Report: TAB Punch-List
Function: Test, Adjust, & Balance
Date: 07/08/2025
Completed By: National TAB

PROJECT
Liberty Collective (Liberty Twp, OH)

Project: Liberty Collective (Liberty Twp, OH)

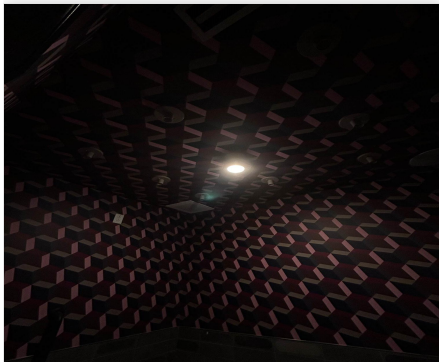
Issue Name : EF 1
Description : EF 1 is above design airflow: 2308/1600 cfm and is not accessible via traditional means. Unable to get an extension ladder tall enough up by RTU 3 to access EF 1 to make adjustments.
Created By : National TAB **Assigned To :** National TAB - Nick Payne
Status : Open
Priority : Medium **Asset Tag :**
Originated Date : 09/09/2025 - Gabe Merk - National TAB
